Re: Culcairn Solar Farm (SSD-10288) – Request to submit Amendment

18-441 Culcairn Solar Farm
Culcairn Solar Farm Constraints Layout

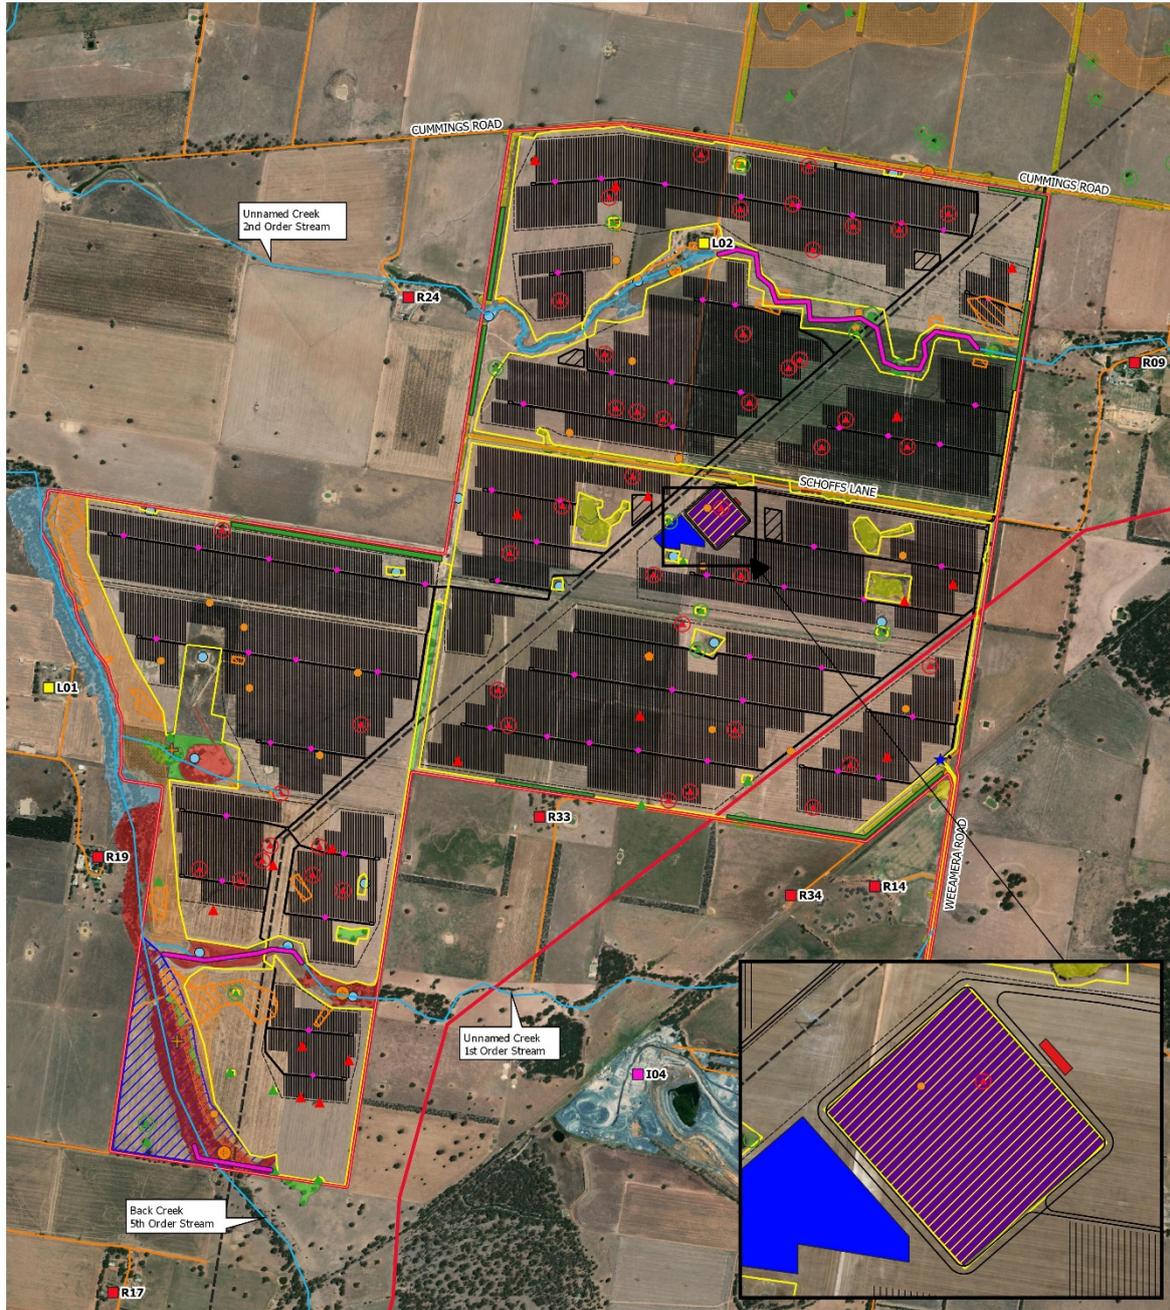
The new development footprint is 892 hectares, reduced from the original 1256 hectares in our Scoping Report. To achieve this reduction, the land north of Cummings Road is now excluded from the development application. According to the Agricultural Impact Statement prepared by Riverina Agriconsultants (Appendix A of the Amendment Report), this land is *“generally more productive due to the presence of more fertile soil on the Billabong Creek floodplain”* and has *“a higher production potential than the other two farms”*.

Consequently, the following lots have been removed from the proposed development:

- Lots 9-11 DP 753735,
- Lot 1 DP 179854,
- Lot 114 DP 664997.

The updated project layout is presented in Appendix A and the updated regional context map is provided in Appendix B.

Appendix A Infrastructure Map

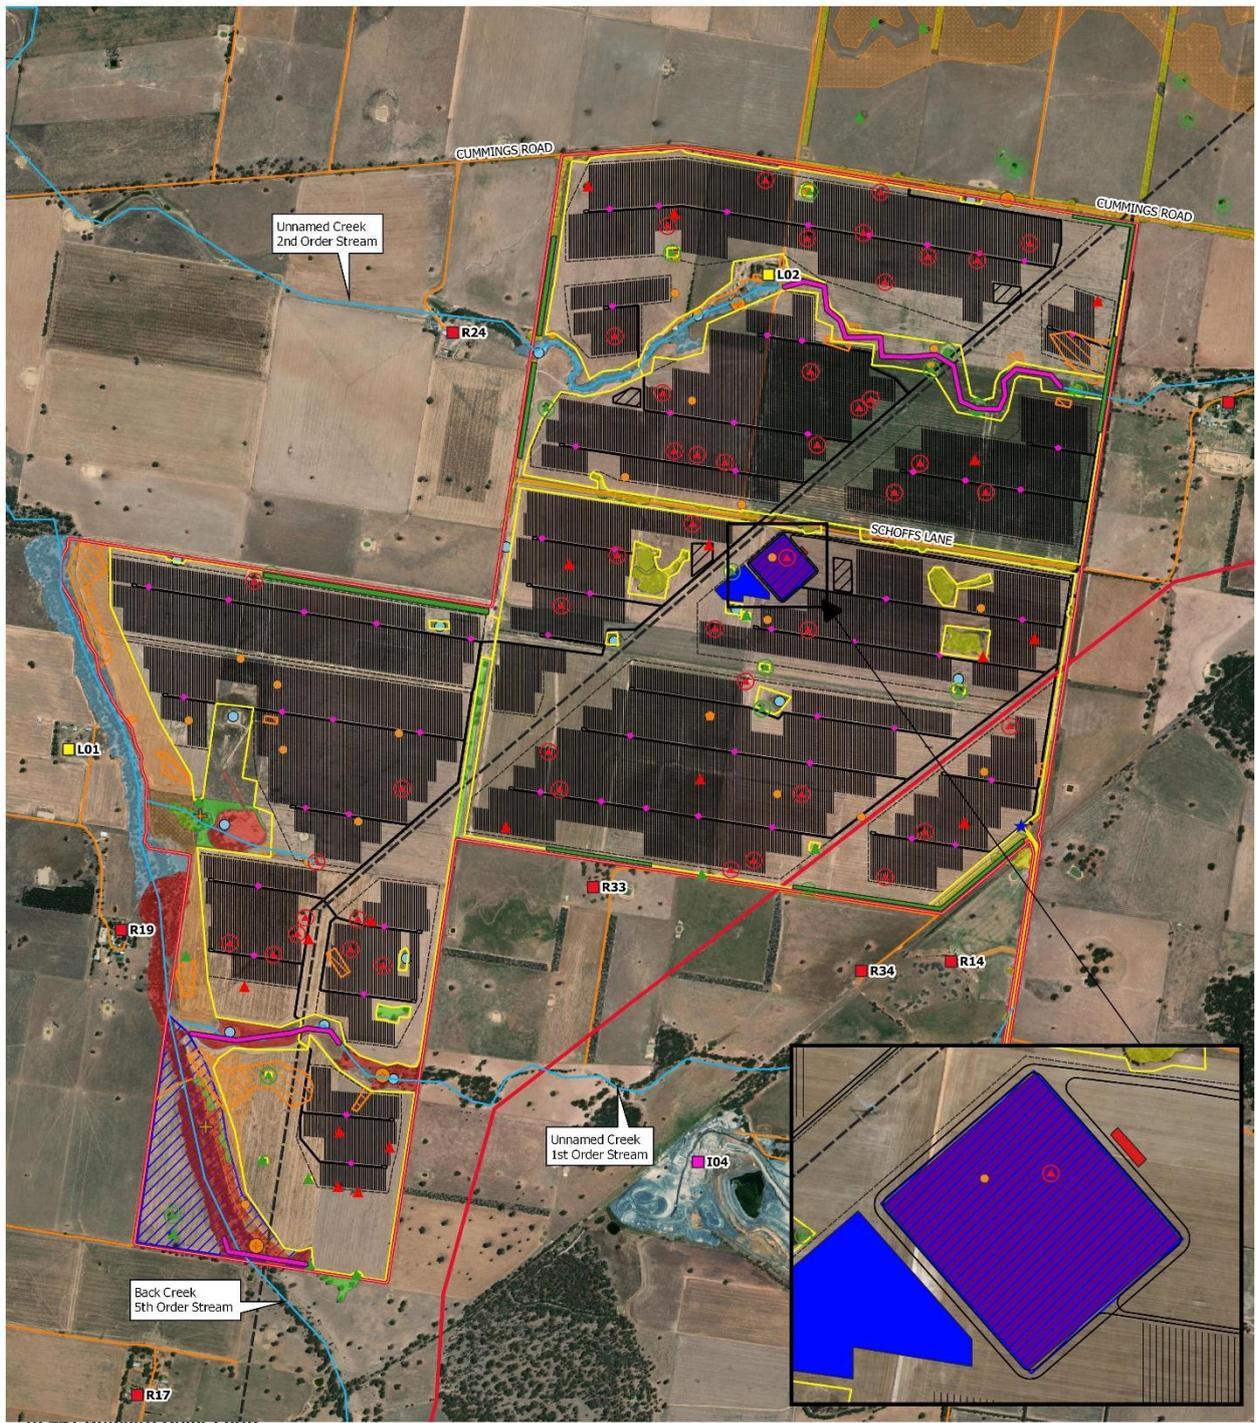
In consultation with DPIE the proposed Culcairn Solar Farm development footprint was reduced in September 2020. This included removal of the paddocks north of Cummings Road (Appendix A). The development footprint has been reduced from 1084 ha to 892 ha.

Based on the revised development footprint (NGH, September 2020), the following changes have occurred:

- Paddock trees requiring offset has been reduced from 77 to 64. Of the further 13 paddock trees to be retained, 9 of these are hollow bearing. The number of hollow bearing trees has been reduced from 58 to 49. The credit obligations for paddock trees has been reduced from 73 to 61.
- Ecosystem credits for PCT 277 exotic understory have been reduced from 3 to 2. This is due to no longer requiring access across Cummings Road to the north. This has reduced the overall credit obligation for PCT 277 from 8 to 7.
- Species credits for each species have increased from 4 to 5. This has increased the overall credit obligation for species from 12 to 15.

Appendix C Updated Heritage Maps

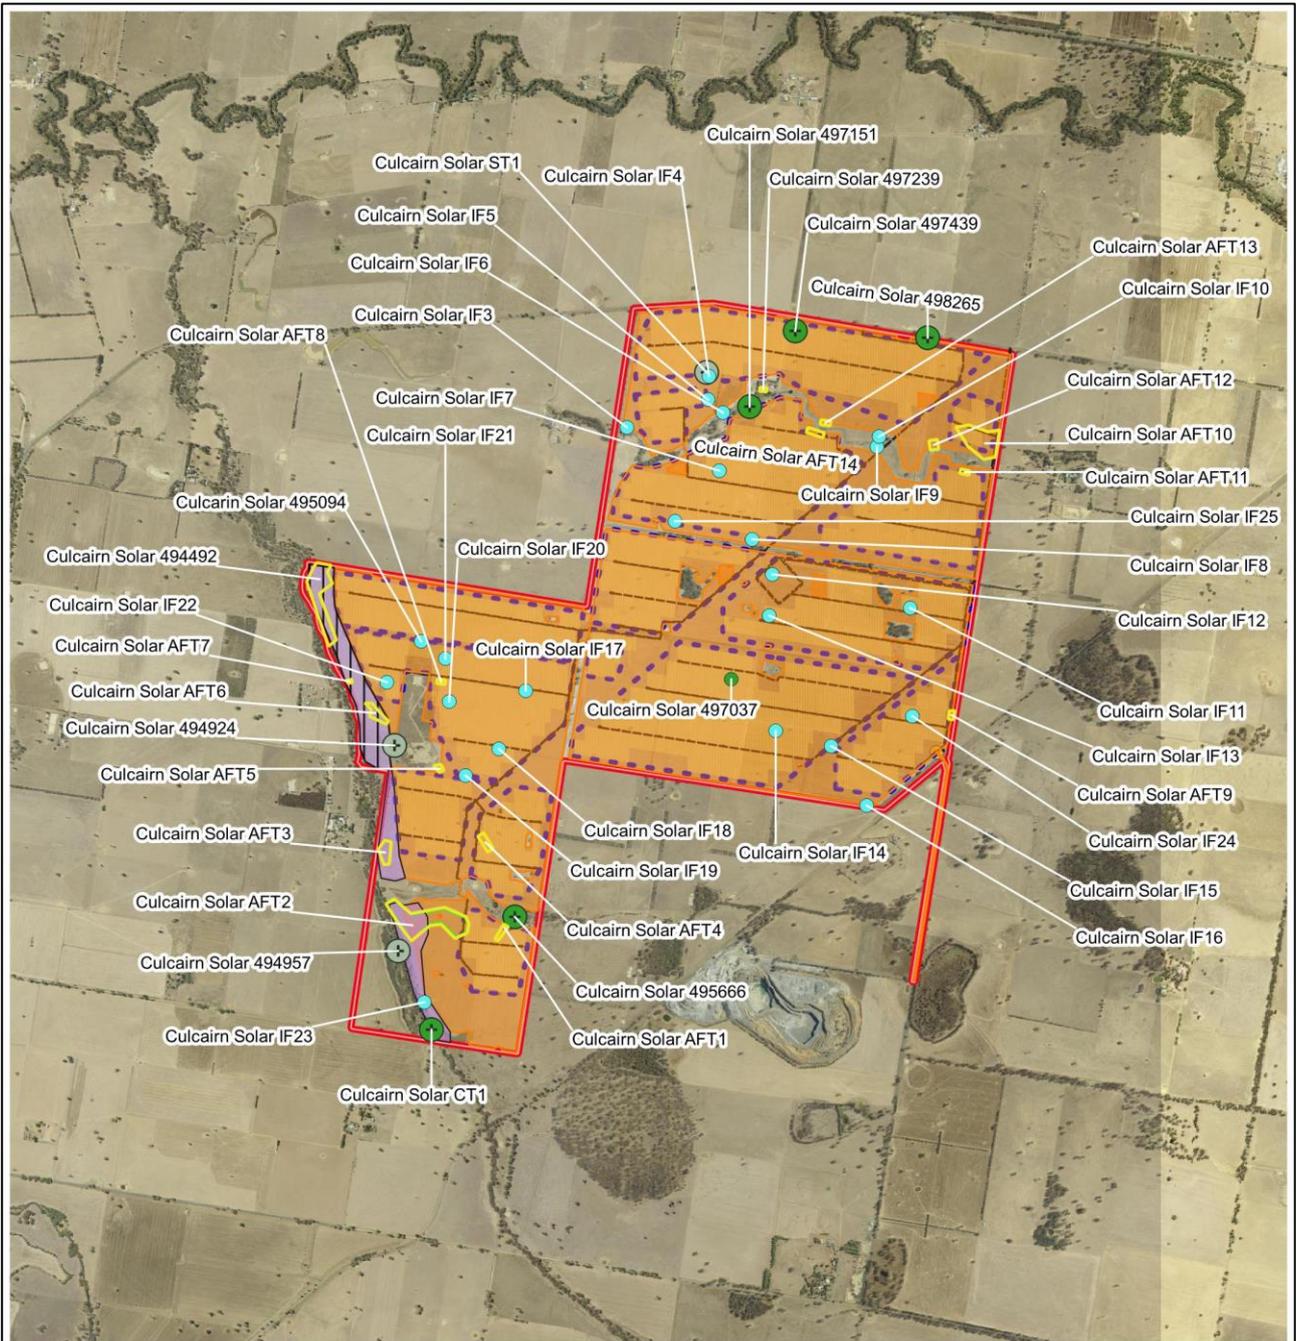
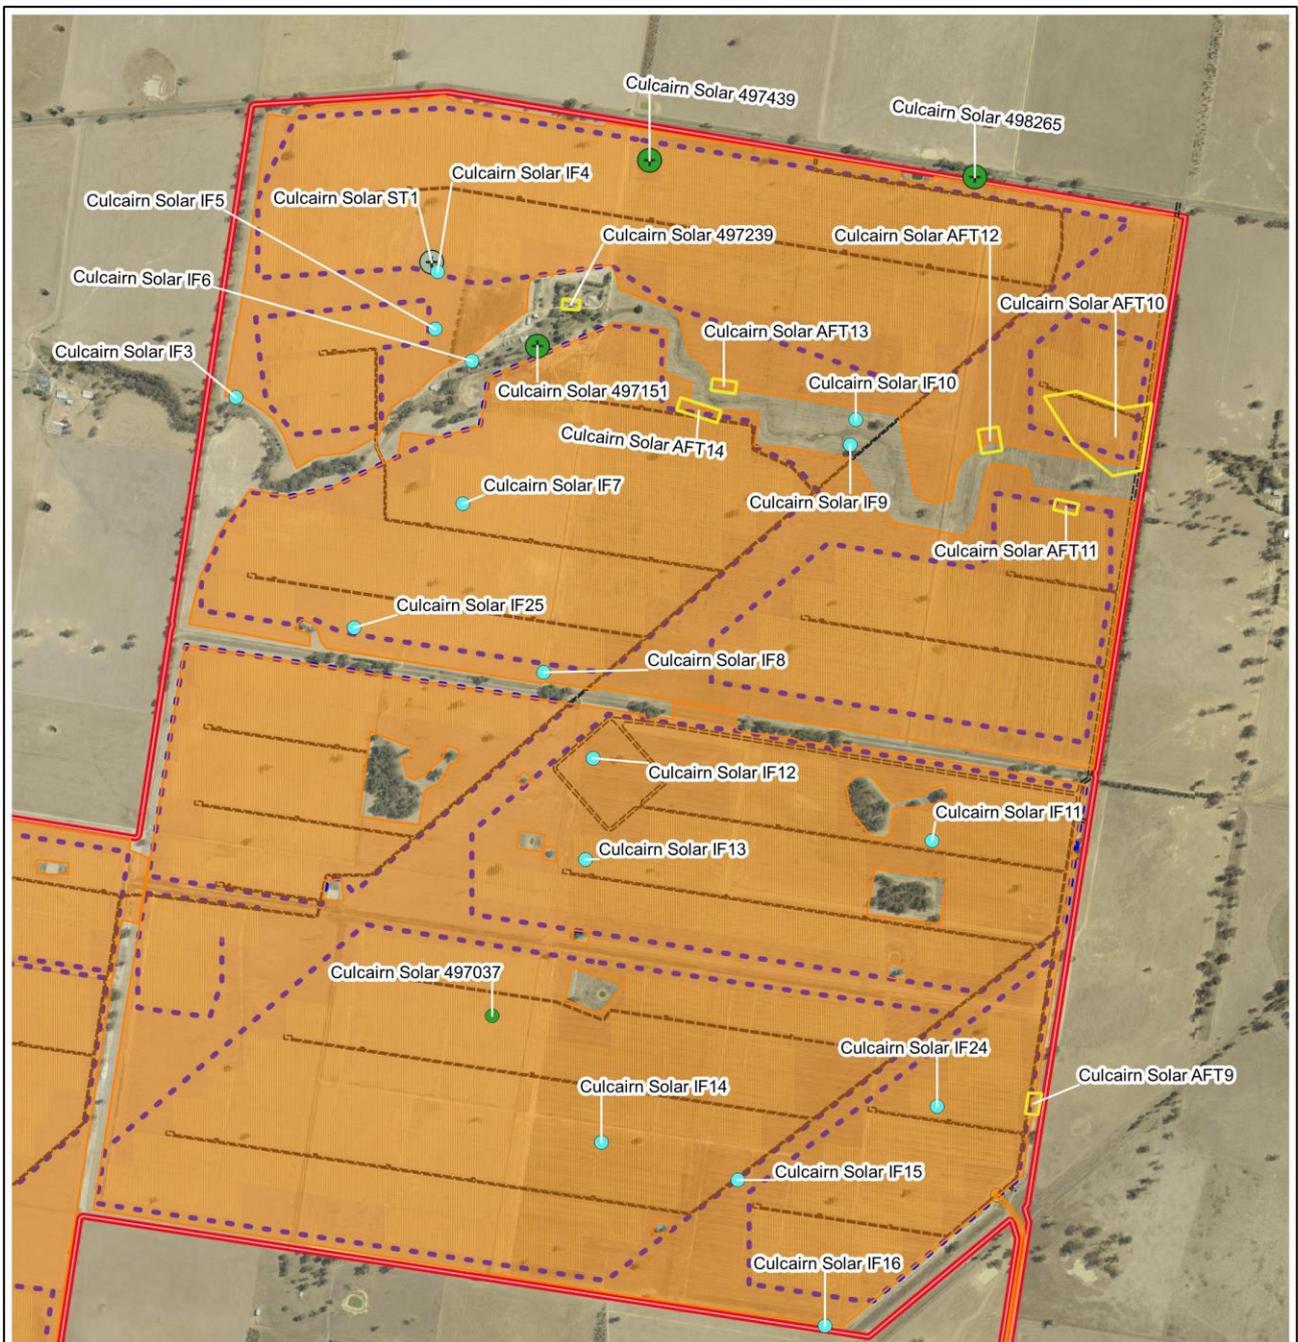
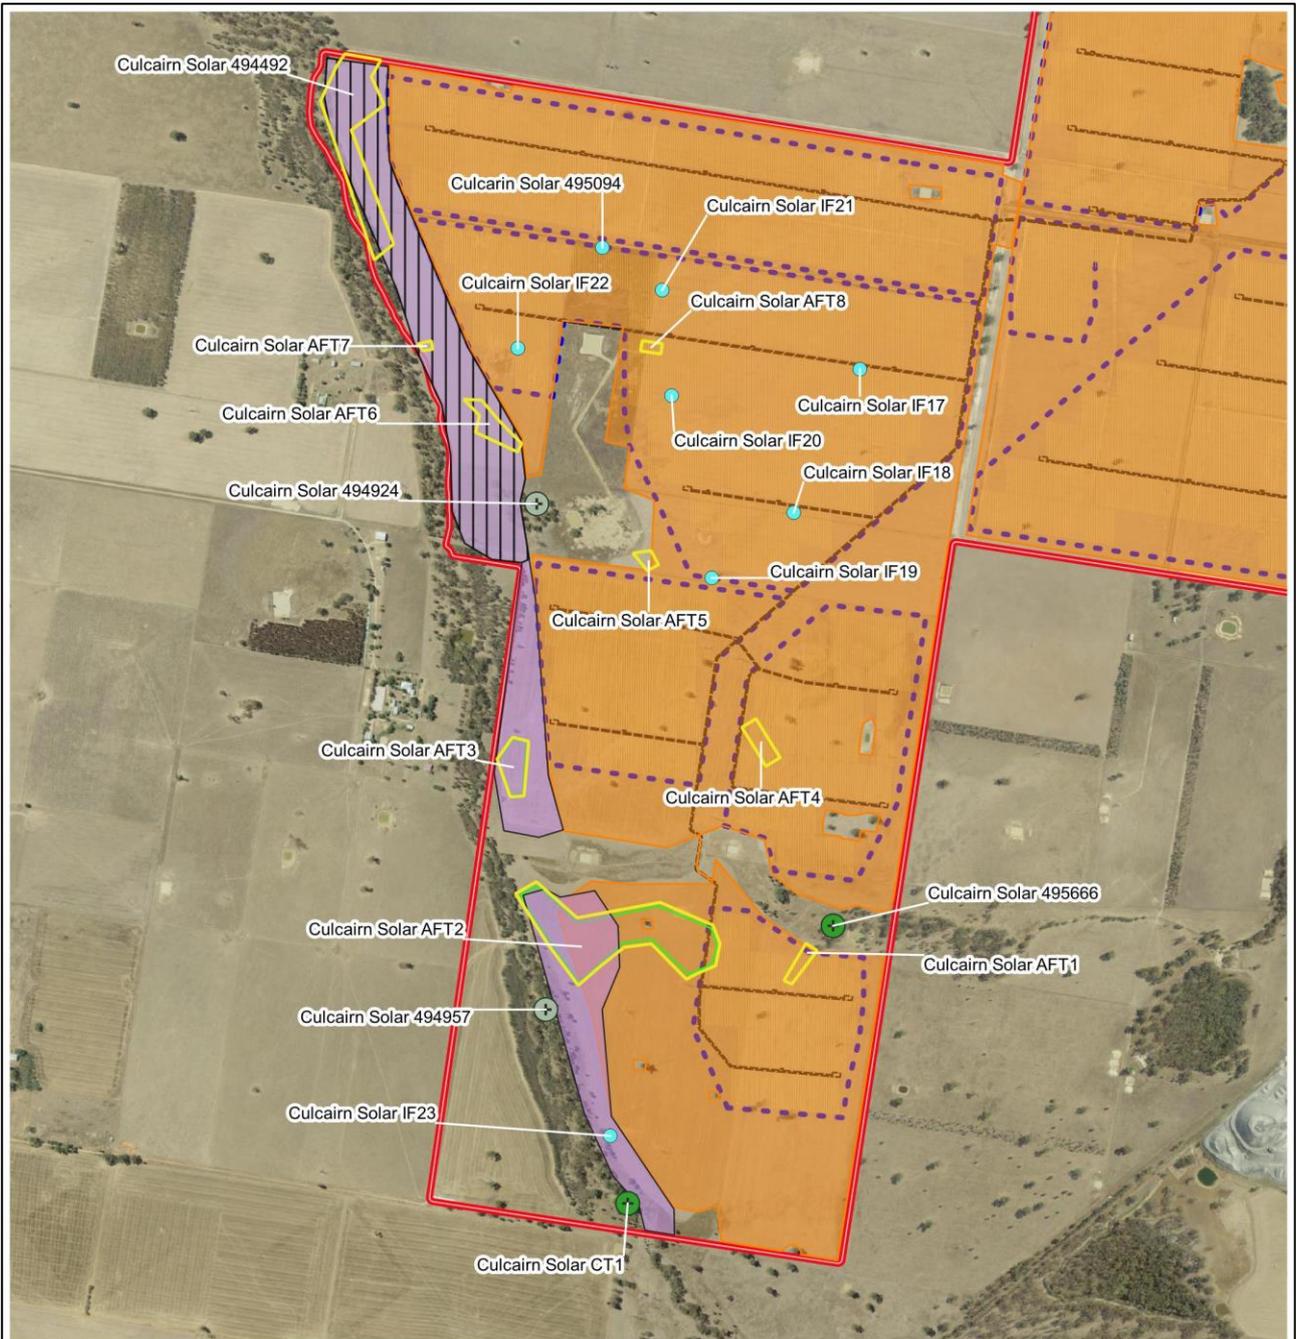
The updated heritage sites to be impacted and avoided are provided in Table 2-1, with updated maps shown in Appendix C.

Access Design

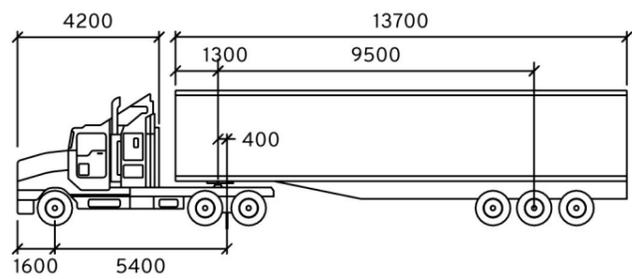
Access to the site is proposed at the south-eastern boundary of the site via Weeamera Road. The access design and a swept path assessment showing access to the site by an AV are shown within Appendix A. Accordingly, the access is able to accommodate the worst-case design vehicle expected to access the site. The swept path assessment also demonstrates that Weeamera Road will need to be widened in the proximity of the railway crossing to allow simultaneous two-way movement.

Widen Weeamera Road to accommodate two-way movement

**18-441 Culcairn Solar Farm
Culcairn SF Subdivision**

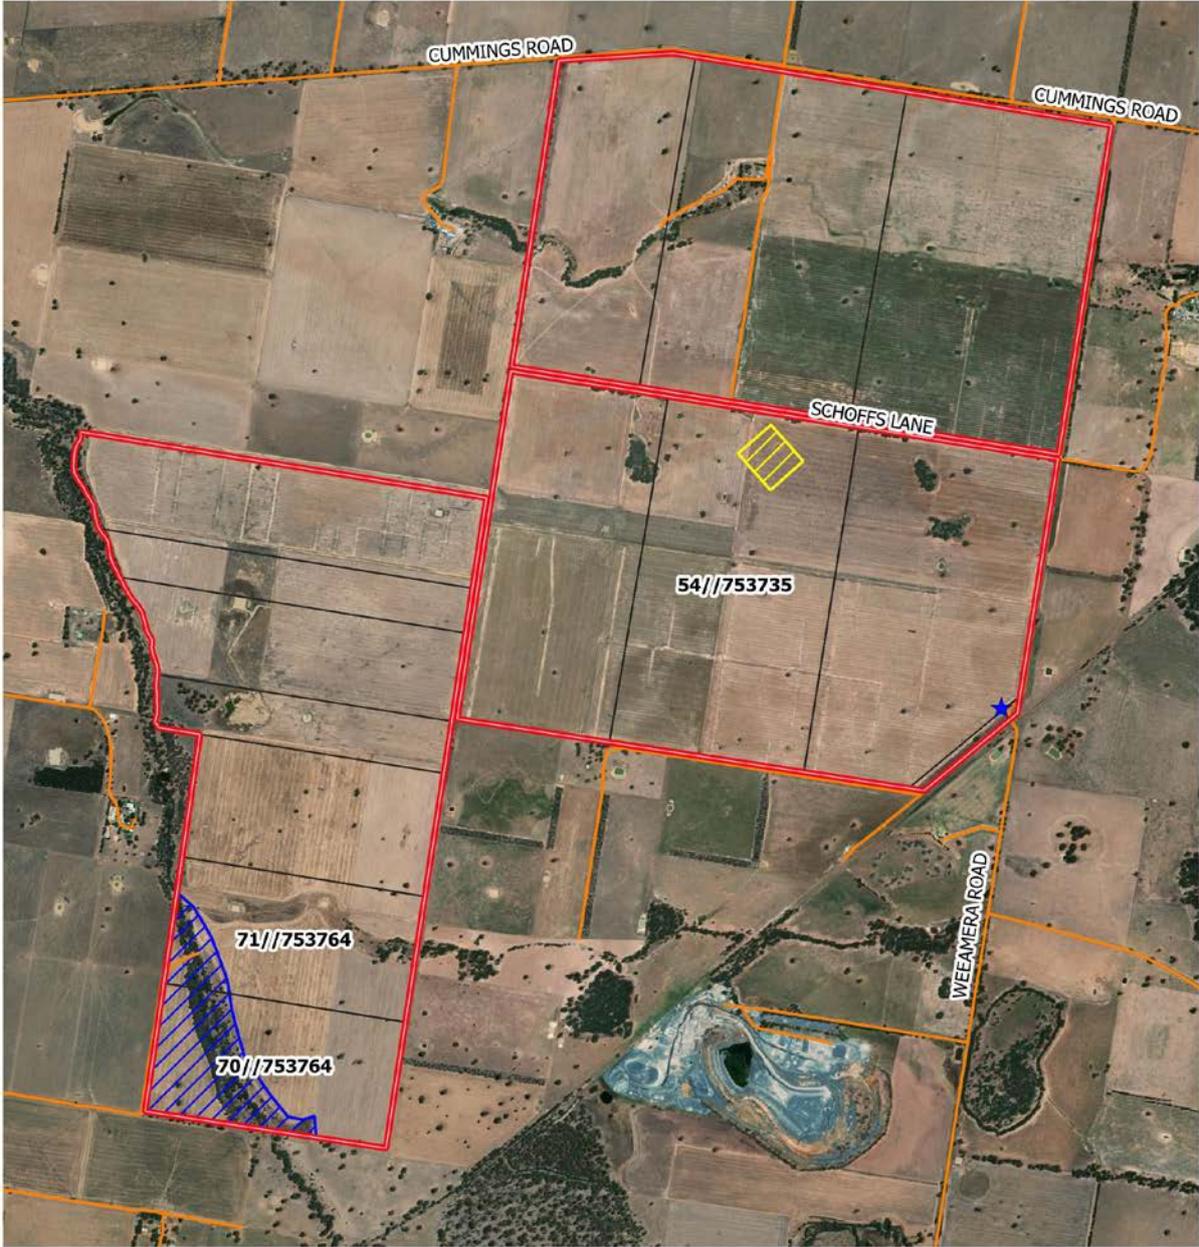
A revised subdivision figure is provided in Appendix F.
